CALL NO. 200
CONTRACT ID NO.
131212 Addendum # 2

Subject: Marshall Trigg County, 121GR13D012 - NHPP 0801 (098)
Letting December 20, 2013

- (1) Revised - Plan Sheets - R2, S2, S134, S183, S184A, S184B, S187, S192, S194, S206, S207, S207A, S207B, S208, S208A, S208B, S209, S209A, S210, S211, S212, S213, S216, S217, S260, S261, S274
- (2) Revised - Cover Page - PAGE 1 of 403
- (3) Revised - Completion Dates - Page 4 of 403
- (4) Revised - Multiple Notes - Various Pages
- (5) Revised - Bid Items - Page 397-403 of 403
- (6) Delete - Pages 27thru44, 216thru233, 207thru215, 234thru238 of 403

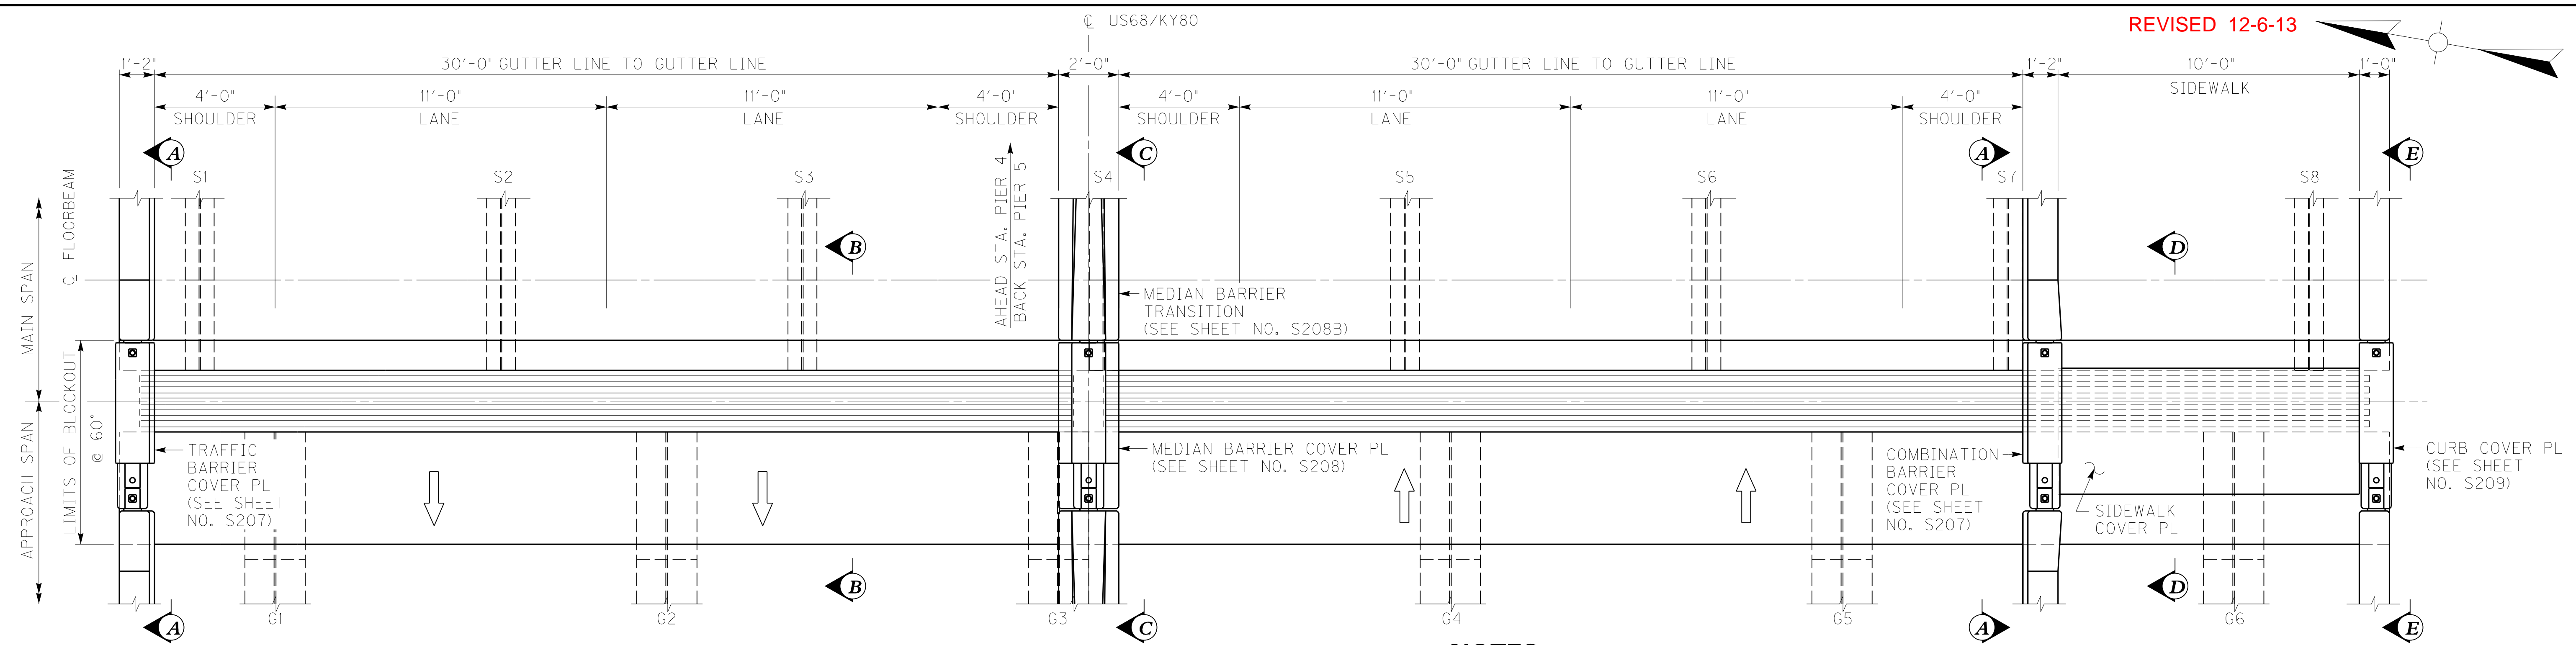
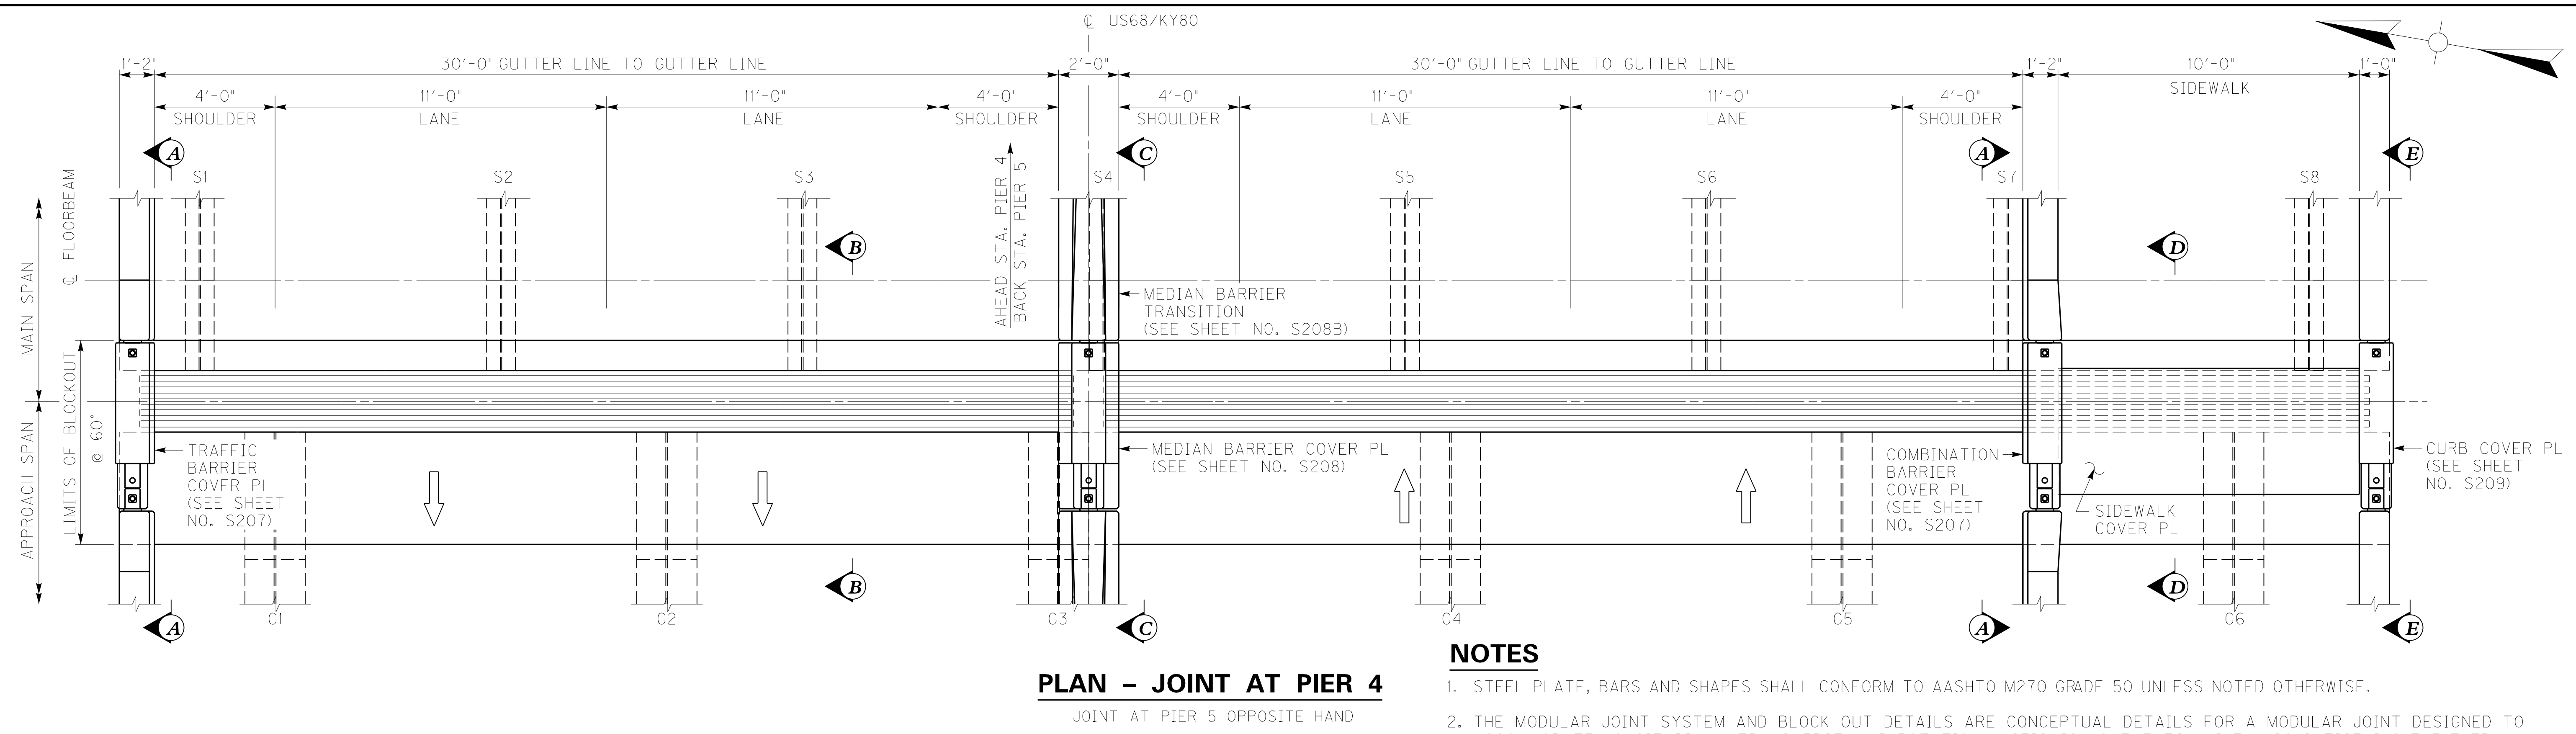
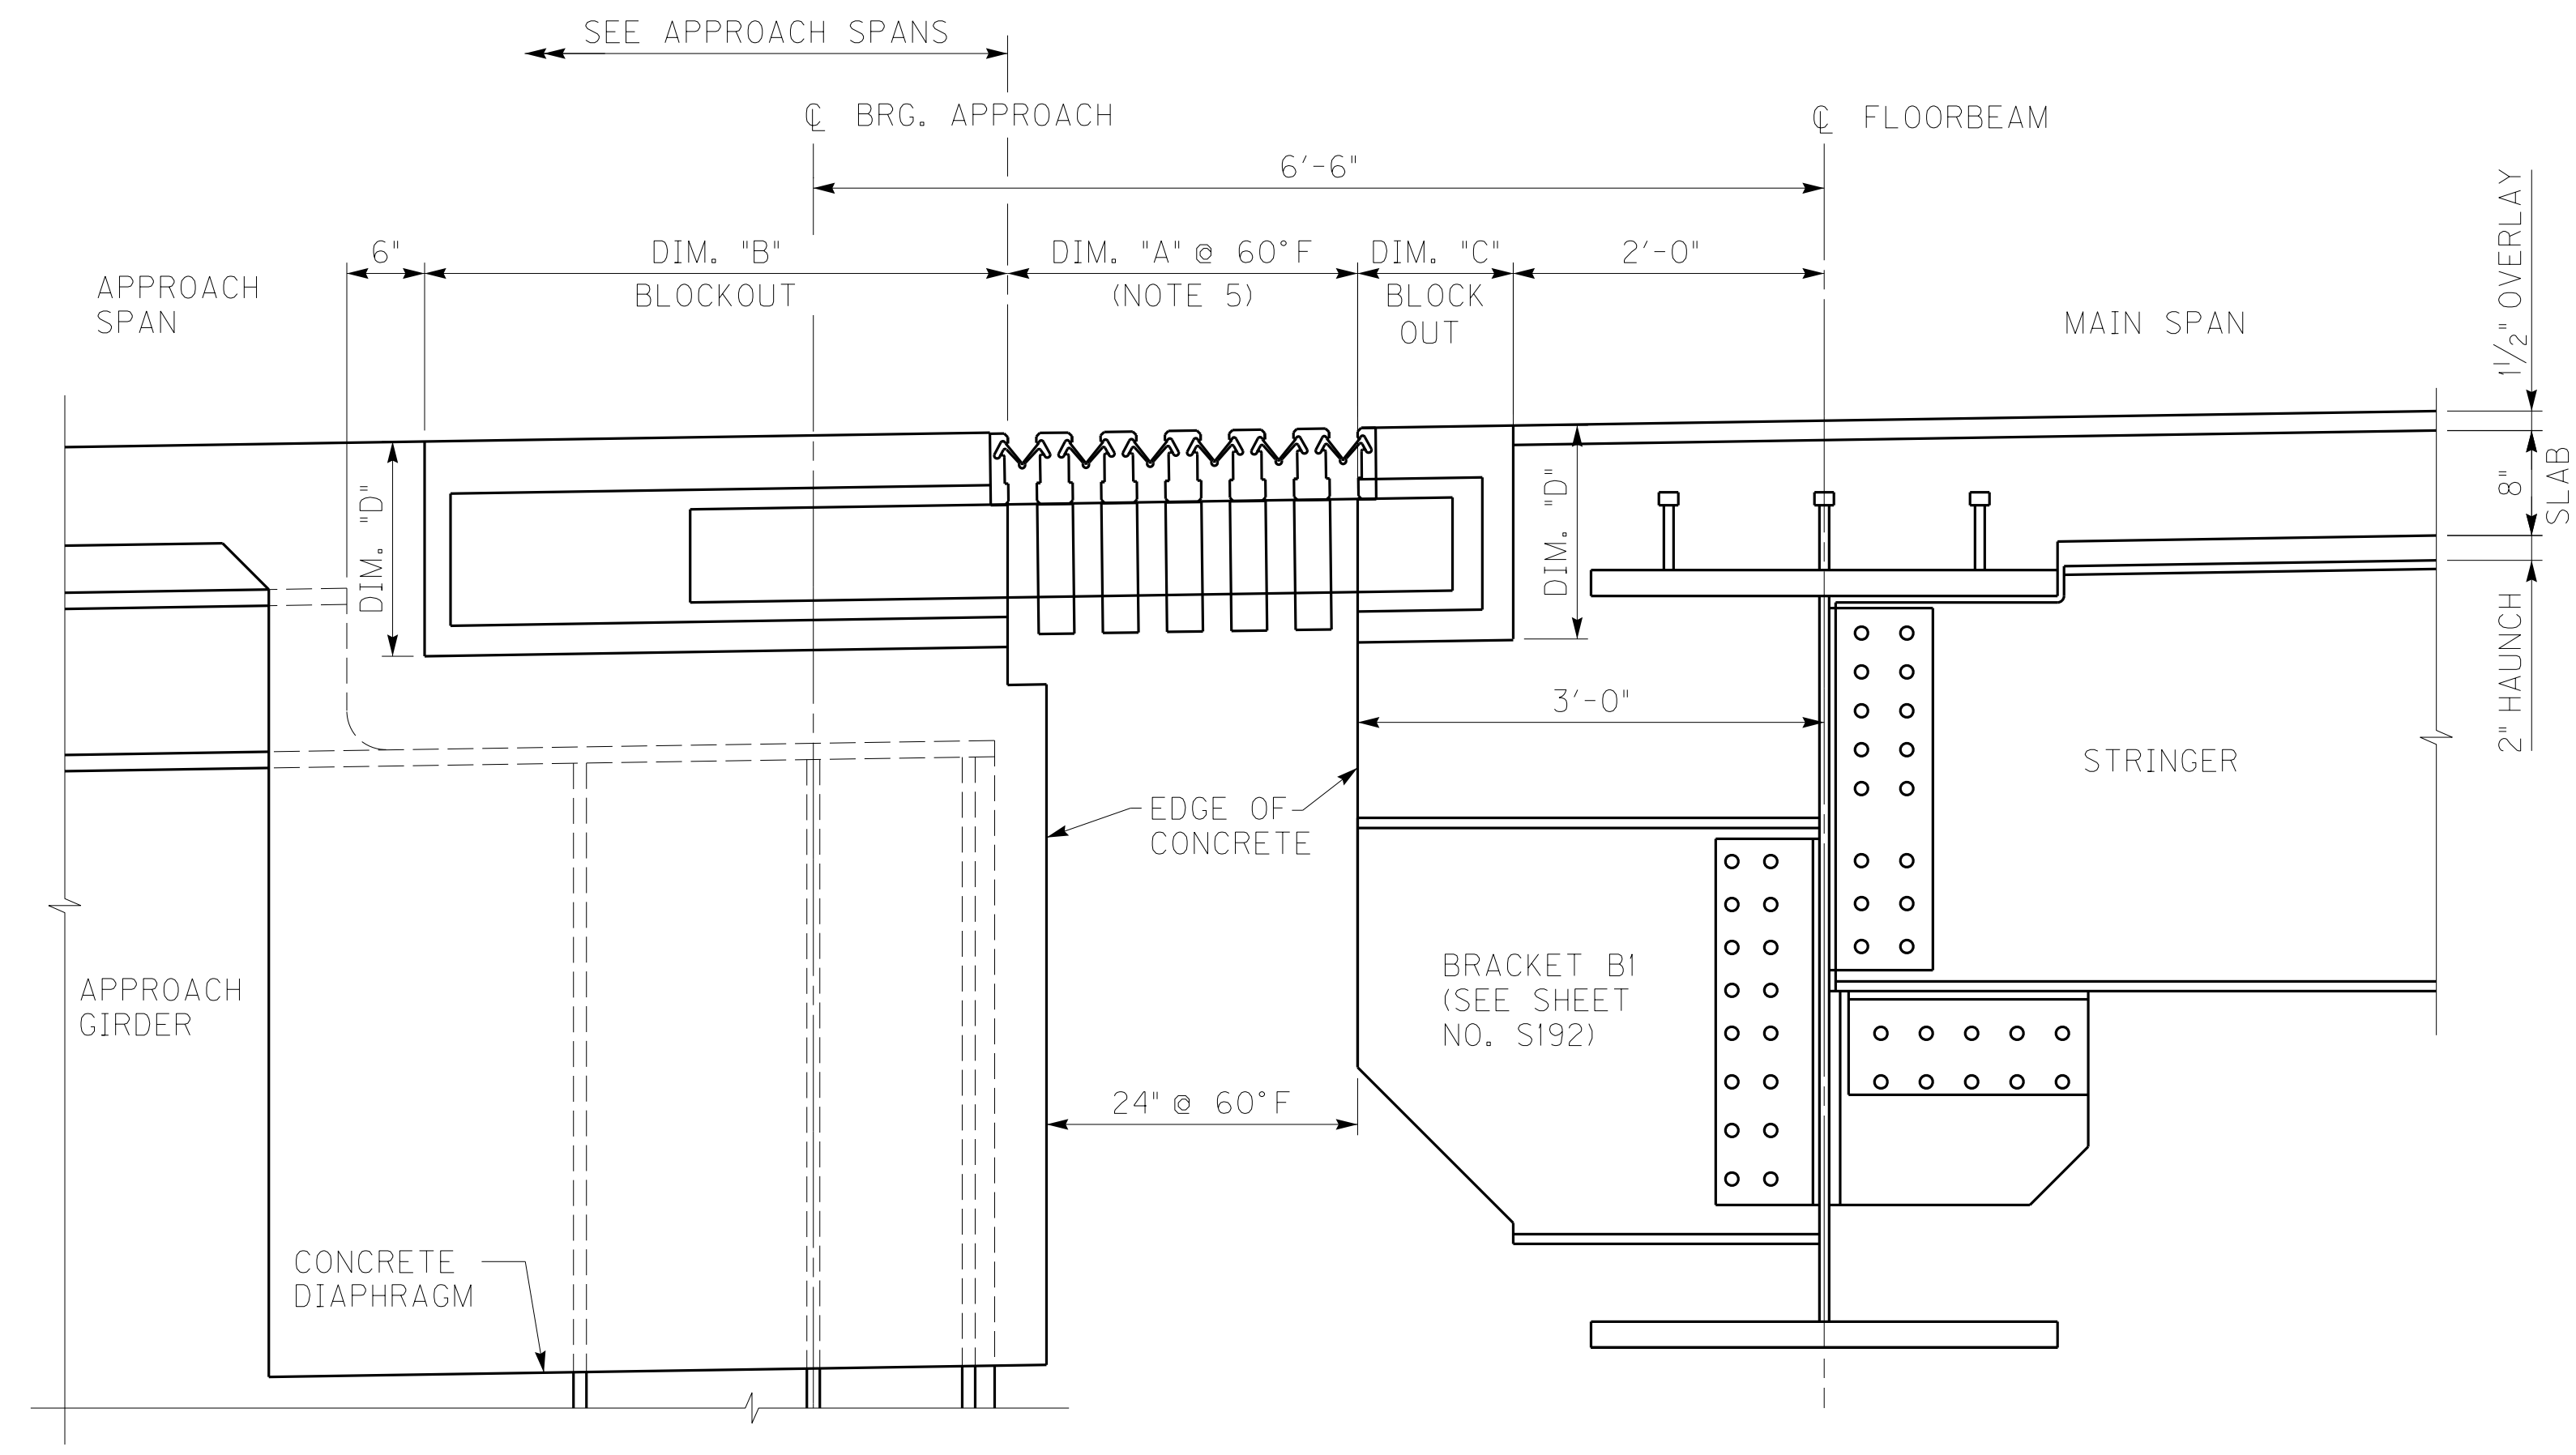
ADD NOTE 10		11/25/13
REVISION		DATE
DATE: NOVEMBER 15, 2013	CHECKED BY	
DESIGNED BY: DMB	TJT	
DETAILED BY: CDR	DMB	
Commonwealth of Kentucky DEPARTMENT OF HIGHWAYS		
COUNTY MARSHALL / TRIGG		
ROUTE US68	CROSSING KENTUCKY LAKE	
MODULAR EXPANSION JOINT		
PREPARED BY		SHEET NO.
MICHAEL BAKER JR., INC. 9750 ORMSBY STATION ROAD SUITE 210 LOUISVILLE, KY 40223		S206
Baker		DRAWING NO. 24686
